PERMITTED DESIGN

PERMIT REVISION

BUILDING SECTION

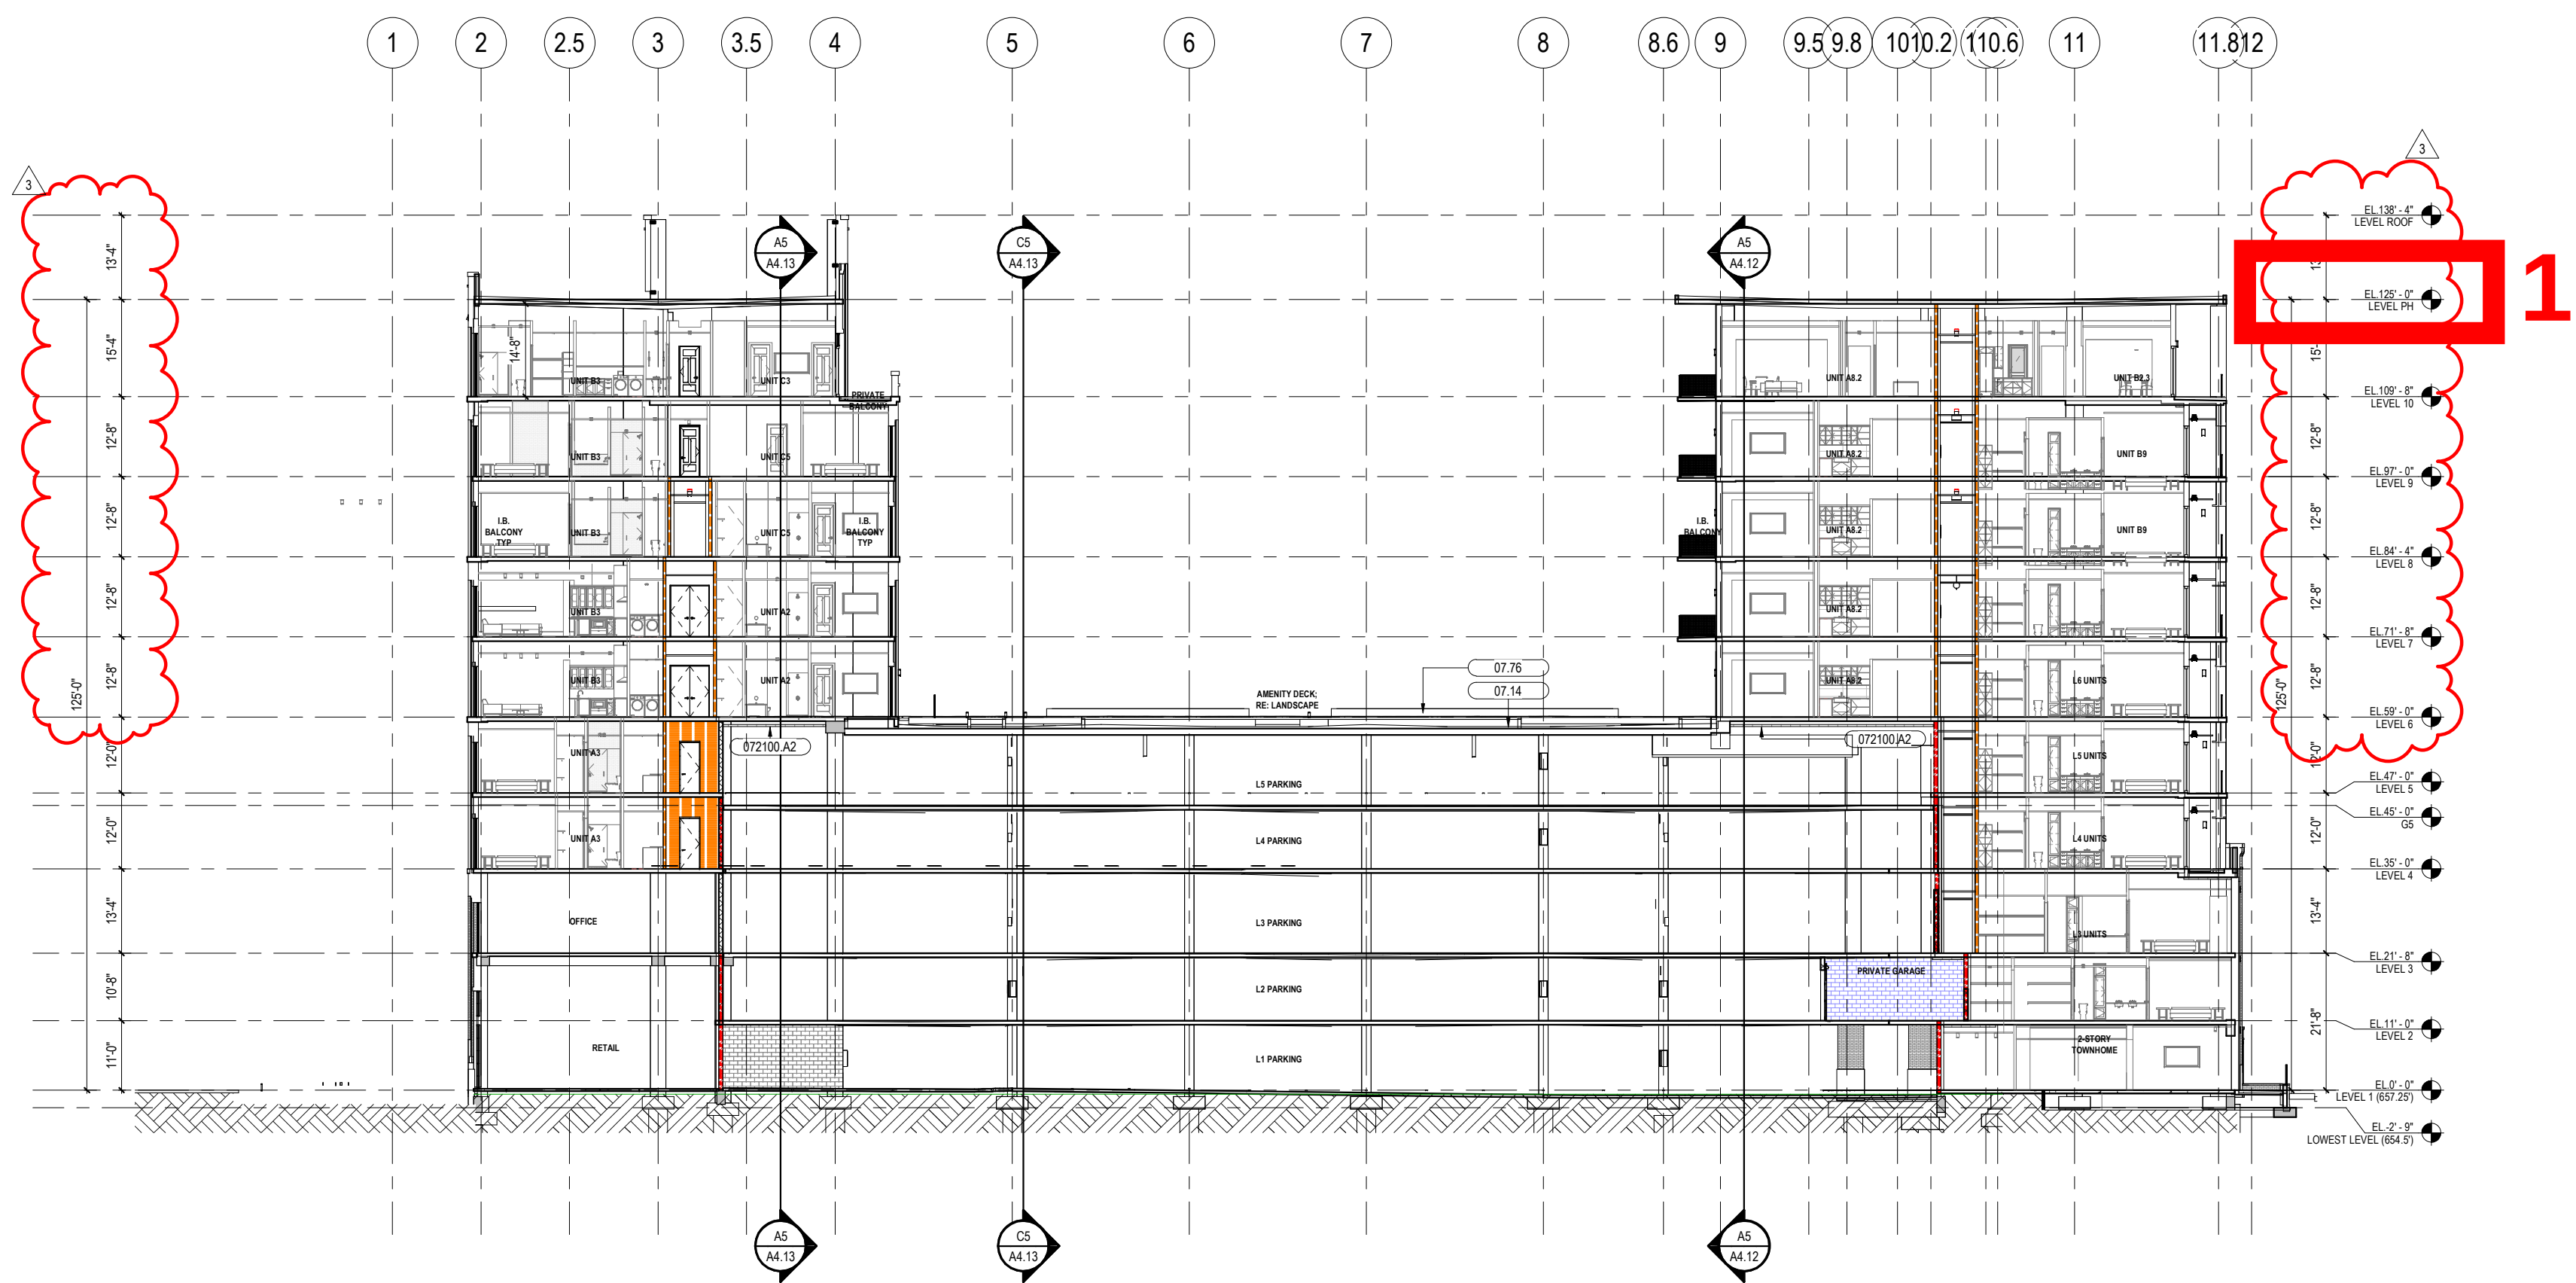
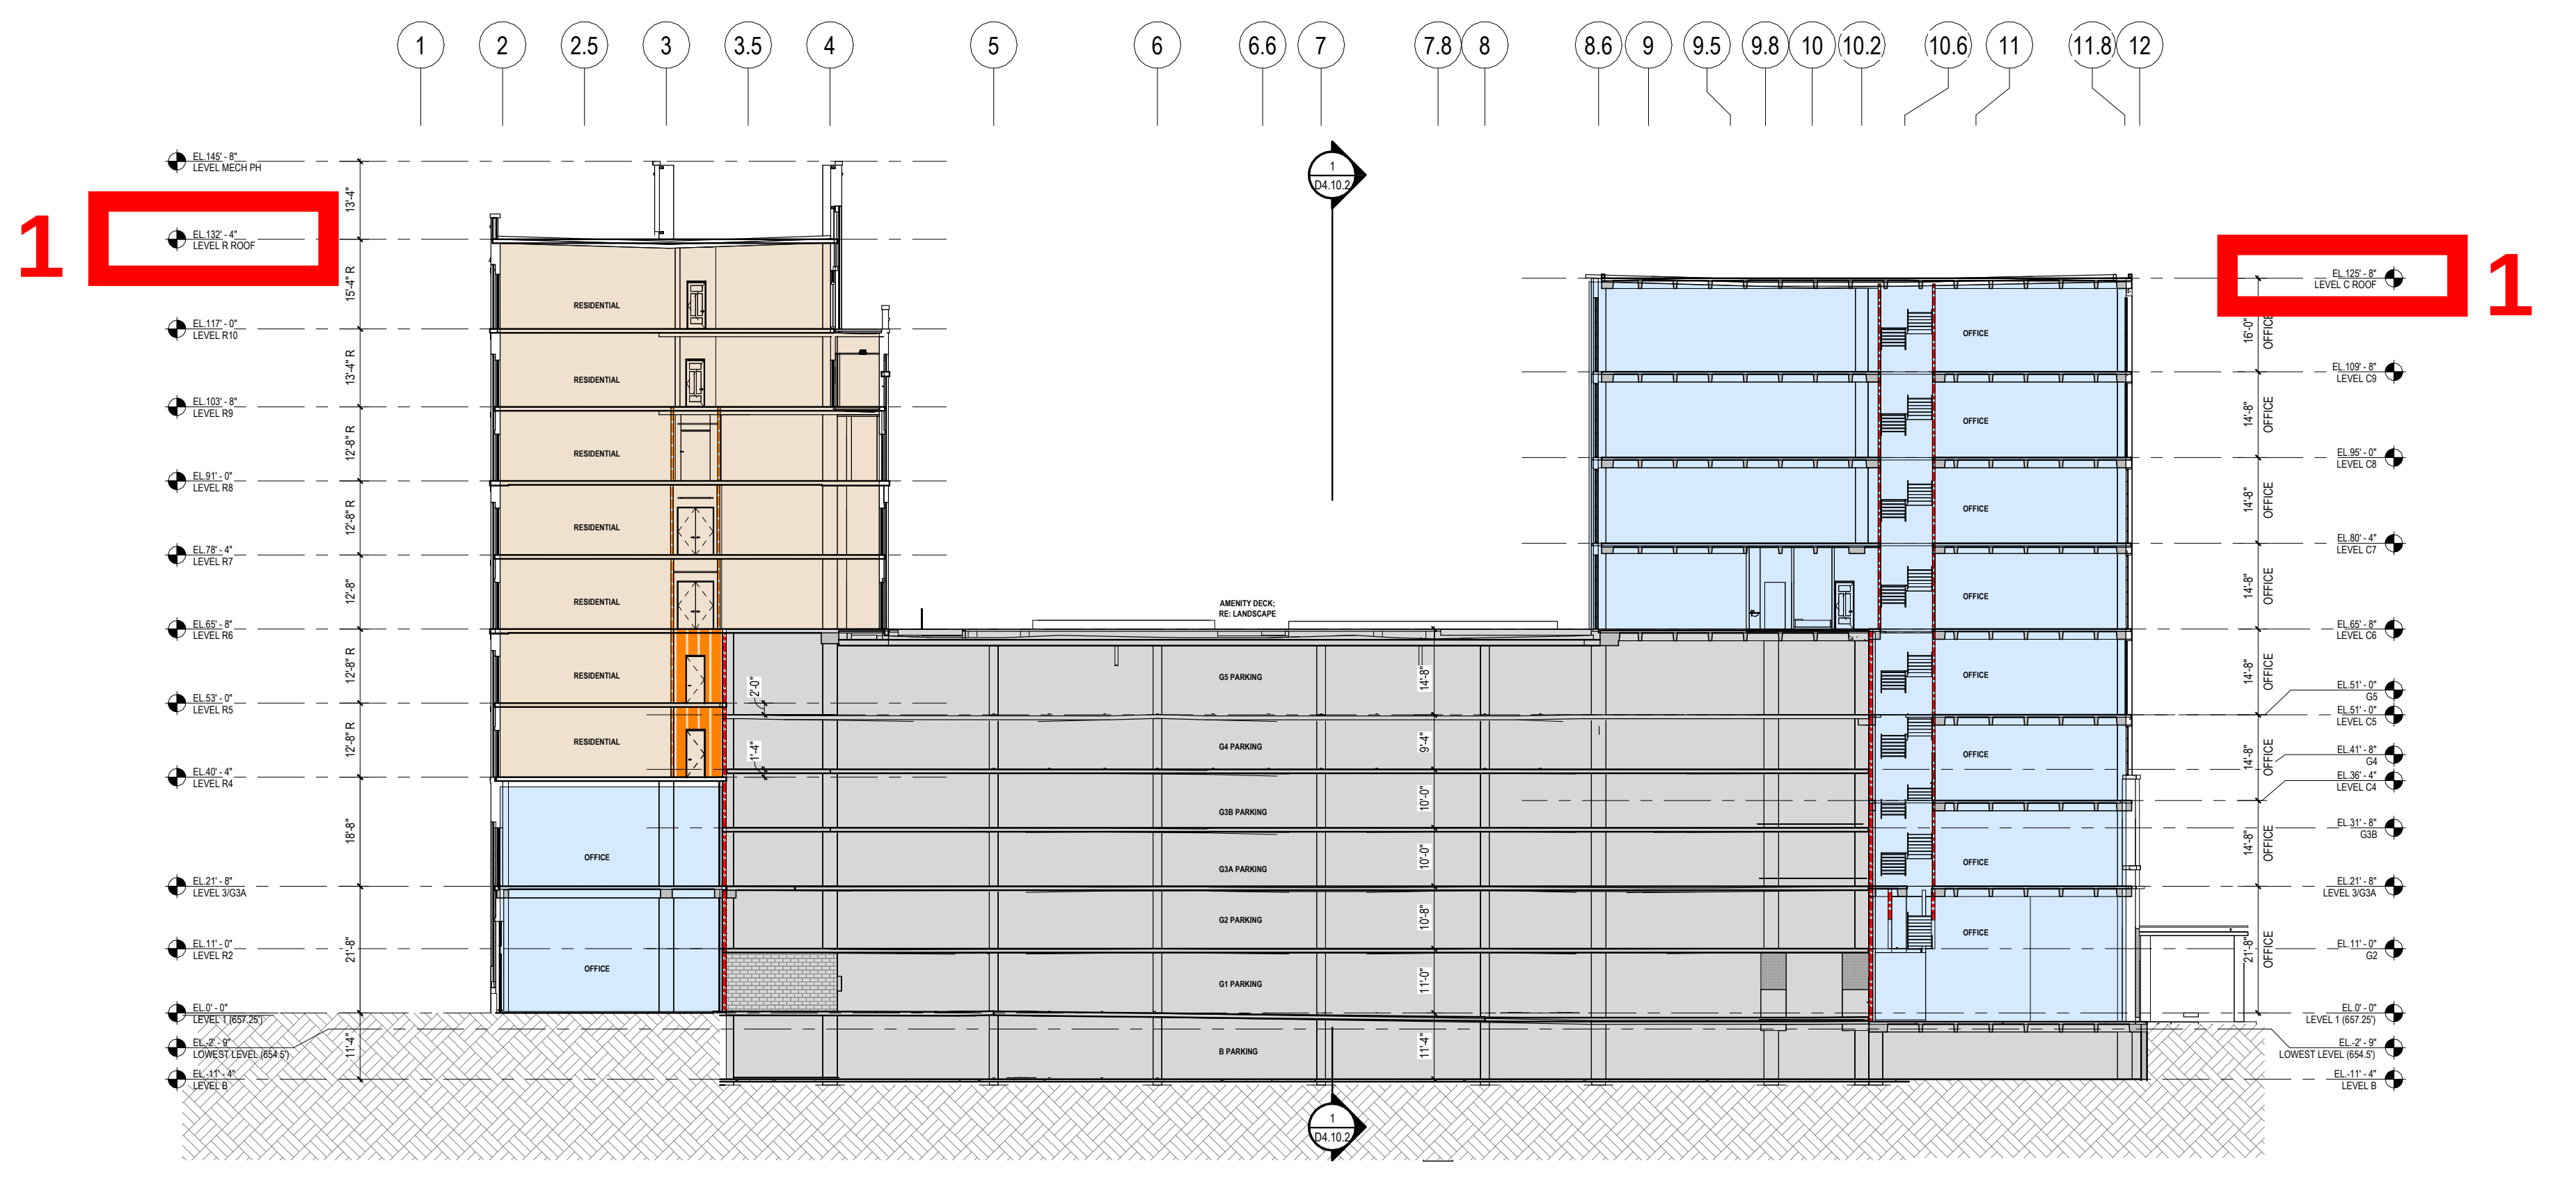
REVISIONS:

- 1. Roof height changed from 125'-0" to 132'-4" (Residential) and 125'-8" (Office).**

General Comments:

- Floor to floor heights revised.
- Basement added.
- Level G3B added in garage between Level 3 and Level 4.

NORTH ELEVATION

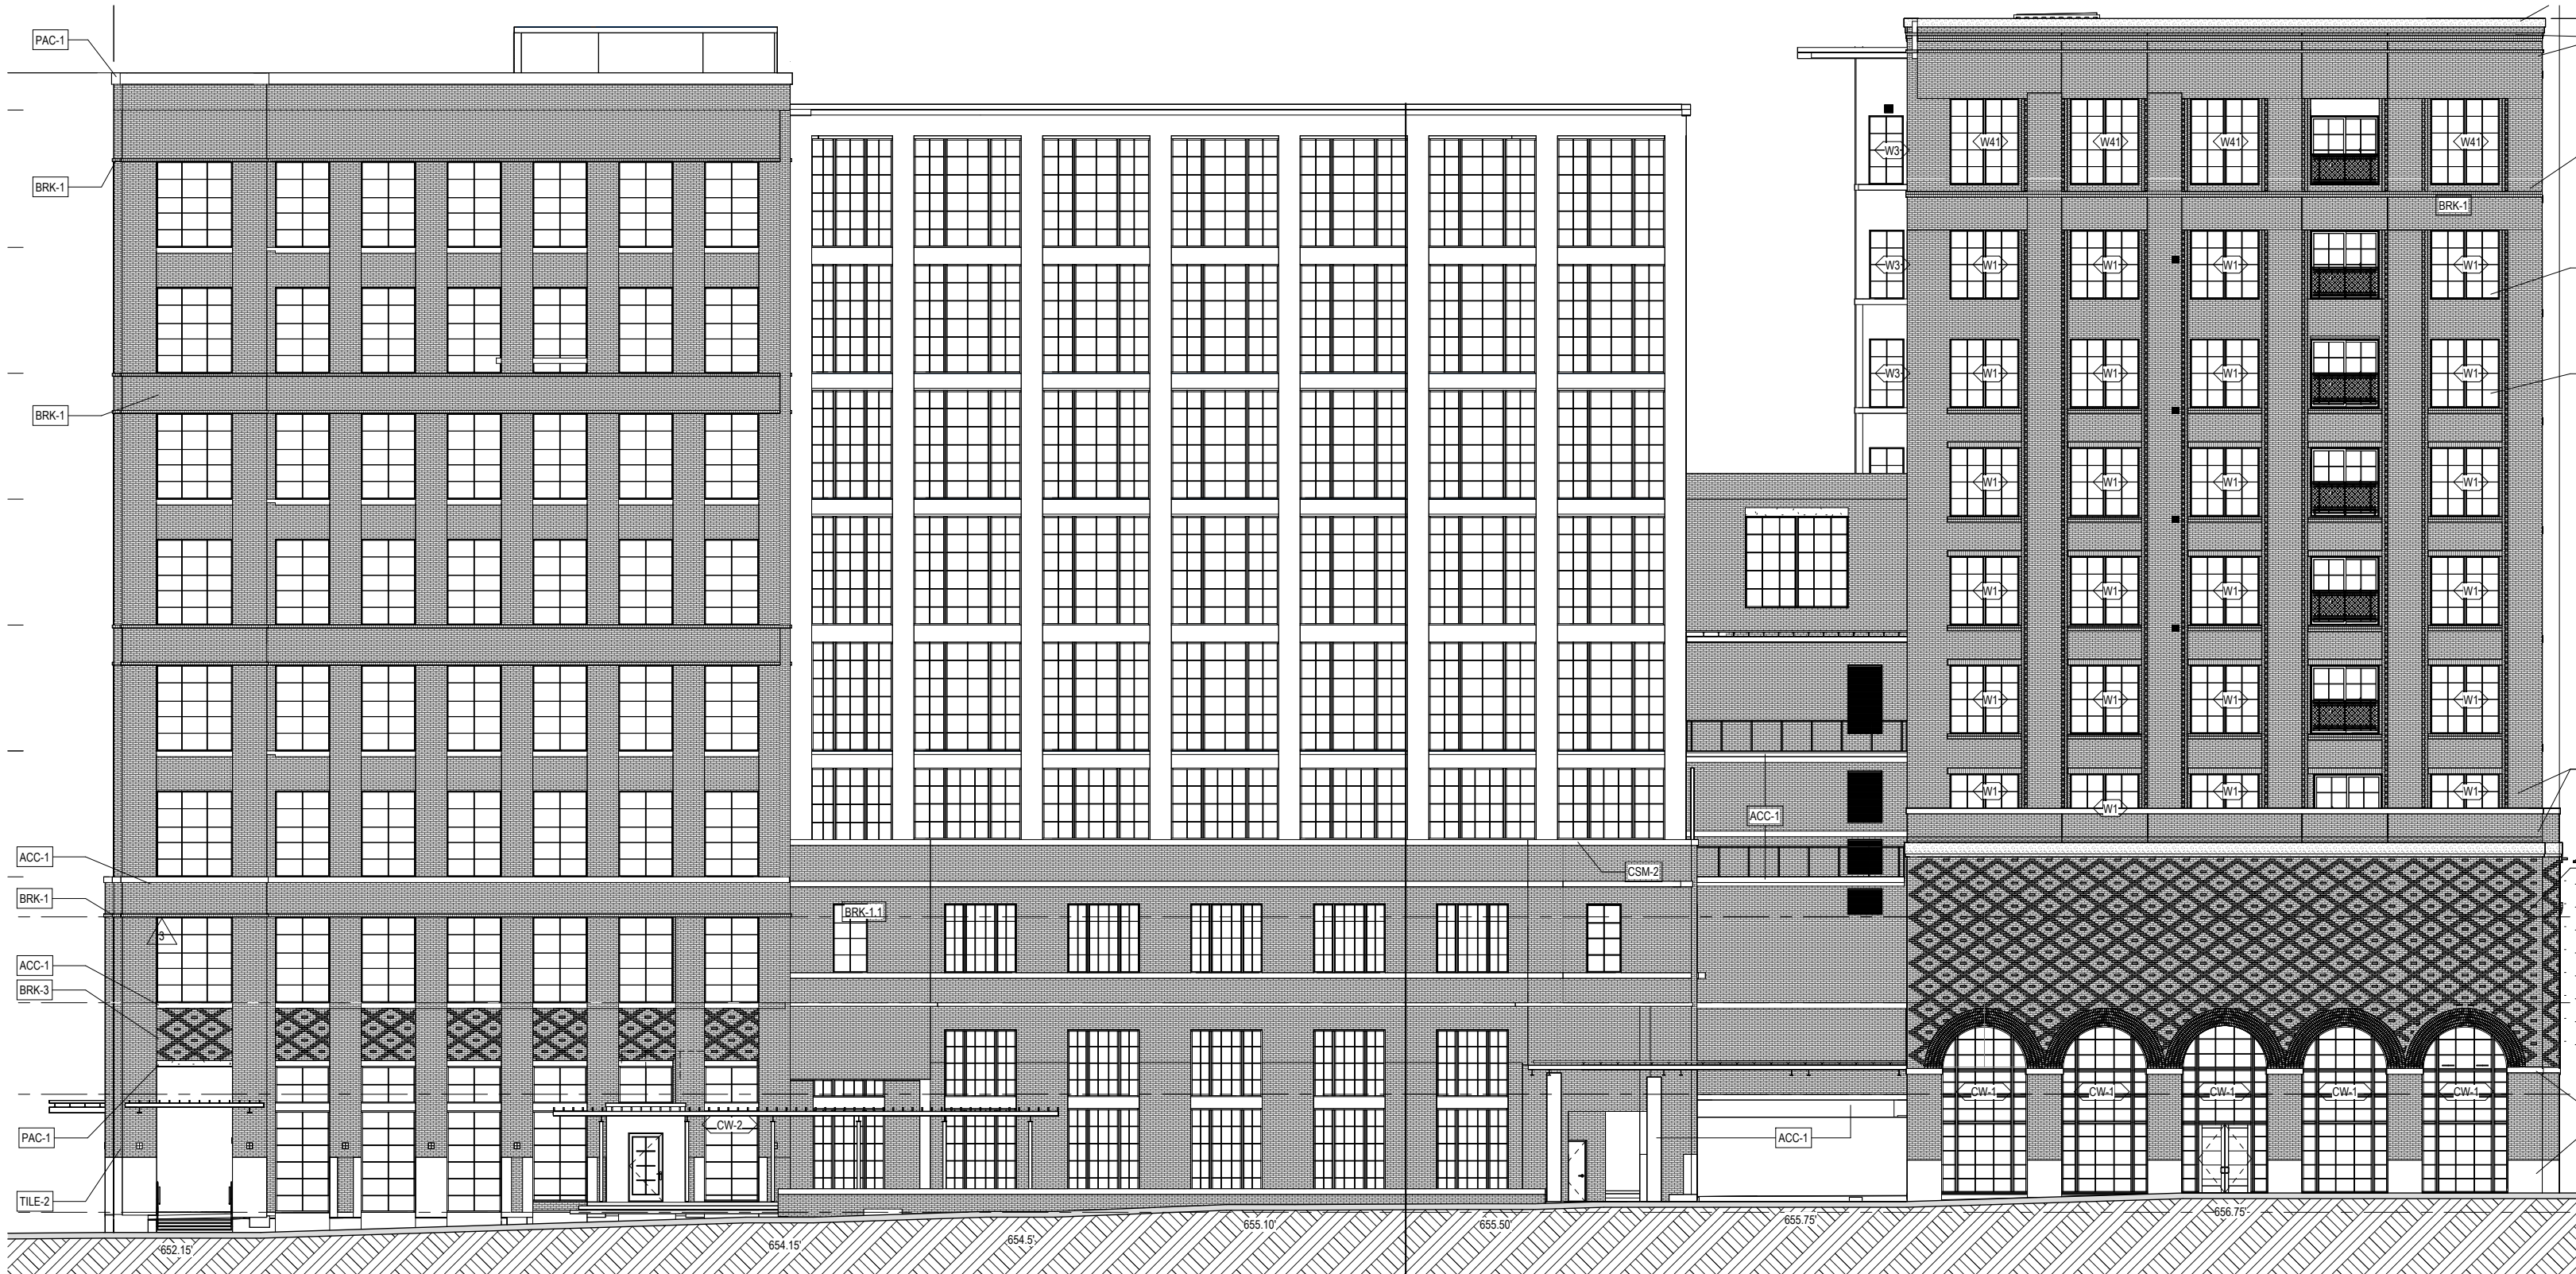
General Comments:
- Floor to floor heights revised.
